**Title: COMBINED STAGE 1-2 ROAD SAFETY AUDIT**

**Ardrew Halting Site, Athy Co. Kildare.**

**Report reference: 2336R01**

**VERSION: FINAL (27-9-2024)**

Drawing 2327-DOB-ARD-SI-DR-CX-0050 S2 P04, Footpaths.

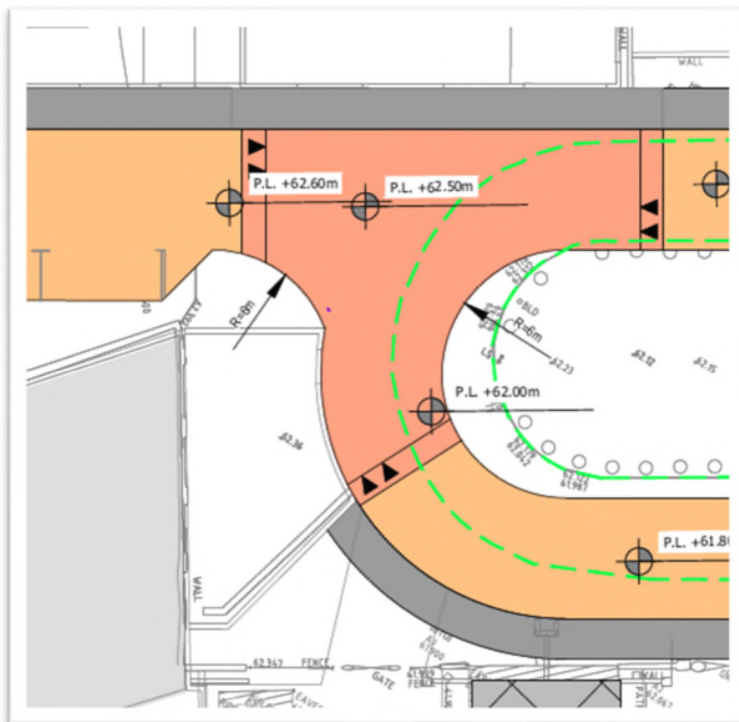
There is a discontinuity in the footpath provision at the western side of the circulatory route. This could result in pedestrians stepping into the carriageway when drivers do not expect resulting in collisions.

It is recommended that a continuous path be provided linking with the path on the northern side.

Drawing 2327-DOB-ARD-SI-DR-CX-0050 S2 P04, Road markings.

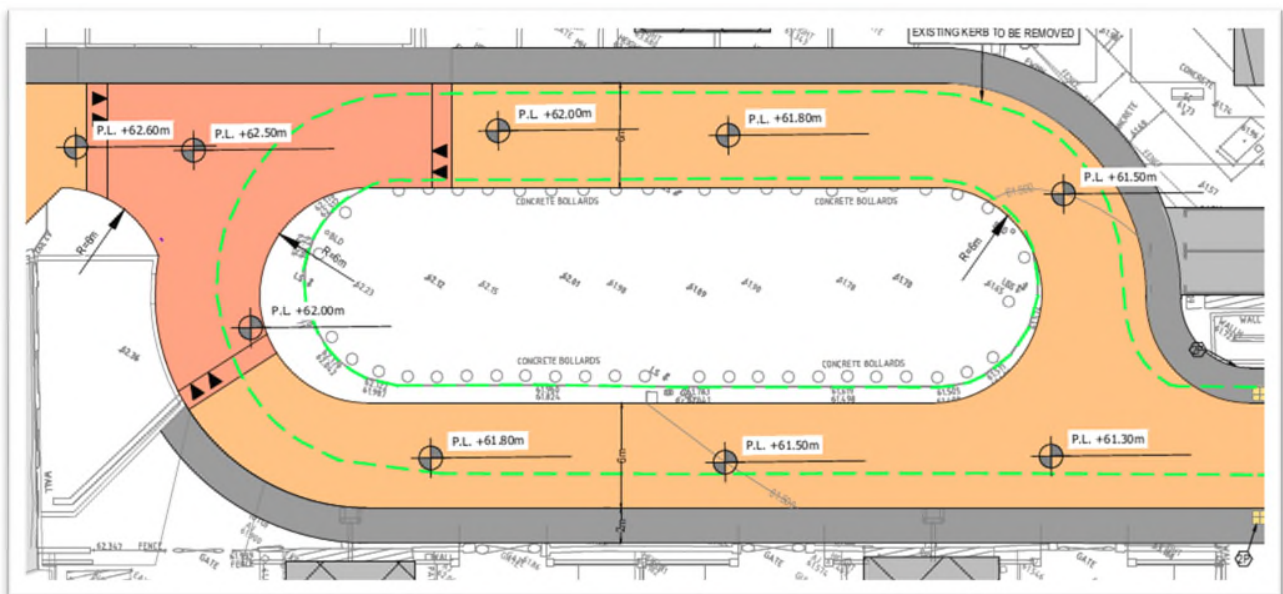
It is unclear if the circulatory route is to be one-way or two-way and with which route the priority is. A lack of clarity could lead to head-on collisions and side-impact collisions.

It is recommended that road markings be provided to confirm the direction of travel and priority at junctions.
